9 October 2015

Urban Design Outcomes Letter – Master Plan for SCEGCS Redlands Senior School Campus at 272 Military Road, Cremorne – SSD 6454

FIGURE 1 – EXISTING SETBACK TO MONFORD PLACE

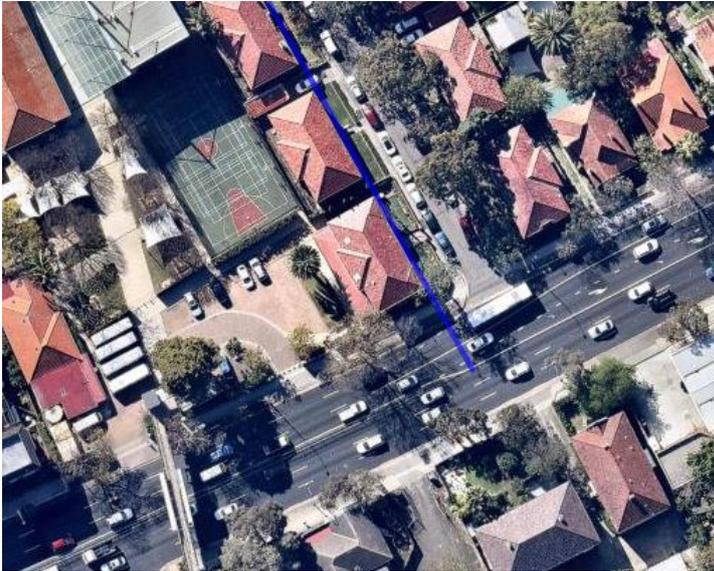
The Department of Planning identified some key issues regarding the bulk and scale of the Sports Hall/ Drama Building. In particular the Department is concerned about the potential impact that the building envelope could have on existing Monford Place residential properties and its relationship with the existing scale of Military Road built form.

North Sydney Council raises specific concerns regarding the scale of the New Sports Hall and Drama Building (Stage 2) fronting Military Road. The New Sports Hall has a maximum building height of approximately 19.9metres and is significantly higher than existing buildings on the adjoining sites B4 Mixed Use and R4 High Density Residential zones that have maximum building heights of between 12m-16m.

- Increase the setback to Monford Place. The proposed setback to Monford Place as lodged with DPE is not generally consistent with the existing character as illustrated by the blue line in Figure 1. An increased setback to Monford Place will minimise the buildings perceived bulk and scale to the streetscape. We suggest the setback for the Sports Hall be in alignment with the existing residential buildings.

- Step down the building height to Monford Place. The proposed building Place as lodged with DPE presents a large continuous building mass to Monford Place with no setback to articulate the streetwall presence of the building. Stepping down the building to Monford Place in combination with an increased setback (as recommend above) will provide an articulated streetwall presence which will make the proposed new building more compatible and sympathetic to the existing surrounding built environment.

FIGURE 3 – EXISTING SETBACK TO WATERS ROAD

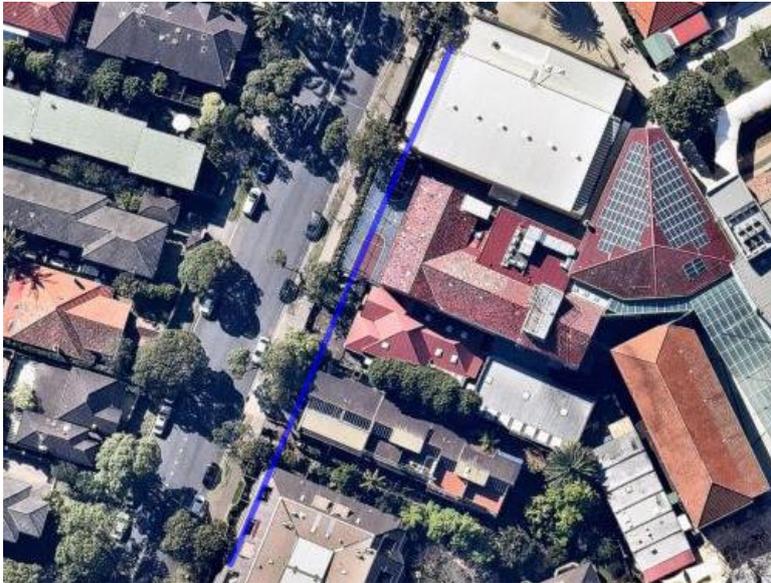
The Department of Planning has concerns regarding the proposed building envelope and the potential impacts on the existing streetscape and adjoining residential properties.

North Sydney Council stated: “*The New Humphreys Building is setback a minimum of 1.5 metres from Waters Road with a maximum building height of approximately 21.4metres. The magnitude of non-compliance is of concern given its close proximity to residential zones that have a maximum building height of 12metres. The proposed building with its minimal setbacks to Waters Road and the likely scale of this building would dominate the streetscape and reduce residential amenity in terms of the loss of solar access to the adjoining property to the south west of the site.*”

Stage 4 of the Master Plan development also received comments from the residents of 19 Waters Road, in particular in regards to setback, building height, over shadowing and rooftop pool.

- Increase the setback to Waters Road. The proposed setback to Waters Road Place as lodged with DPE is not generally consistent with the existing character as illustrated by the blue line in Figure 3. An increased and varied setback to Waters Road will minimise the buildings perceived bulk and scale to the streetscape. We suggest the setback for the Humphreys Learning Hub be in alignment with the Lang Gymnasium.

- Step down the building height to Waters Road. The proposed building as lodged with DPE presents a large continuous building mass to Waters Road with only a single setback to articulate the streetwall presence of the building. Stepping down the building to Waters Road in combination with an increased and varied setback (as recommend above) will provide an articulated streetwall presence which will make the proposed new building more compatible and sympathetic to the existing surrounding built environment.
